## **REMARKS**

Reconsideration of the above-identified patent application, as amended, is respectfully requested.

FIG. 3

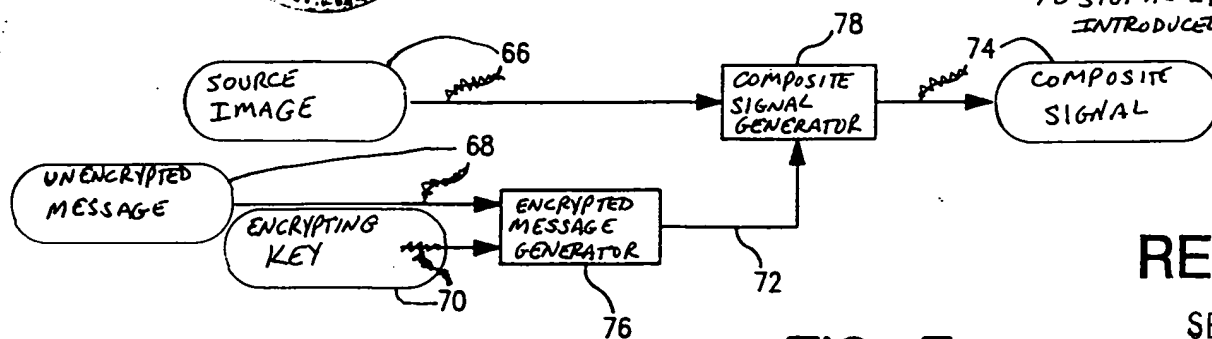
The drawings are objected to as requiring suitable descriptive legends for FIGS. 3 and 4. Applicants accordingly submit herewith a replacement sheet for FIGS. 3 and 4 and an annotated sheet showing changes FIGS. 3 and 4 that introduce functional block and signal descriptions were appropriate. These additions are fully supported in the specification and no new matter has been added.

The attached sheets of drawings include changes to FIGS. 3 and 4. The sheet identified in the top margin as a Replacement Sheet replaces the original sheet containing FIGS. 3 and 4. The sheet identified in the top margin as an Annotated Sheet Showing Changes is a marked-up copy of the original sheet containing FIGS. 3 and 4 showing the changes to FIGS. 3 and 4 in red.

INTRODUCED SIGNAL  
IDENTIFICATION BLOCKS;  
CONSISTENT WITH FIG. 4, MOVED  
REFERENCE NUMBER POINTER LINES  
TO SIGNAL IDENTIFICATION BLOCKS, AND  
INTRODUCED BLOCK DESCRIPTIONS
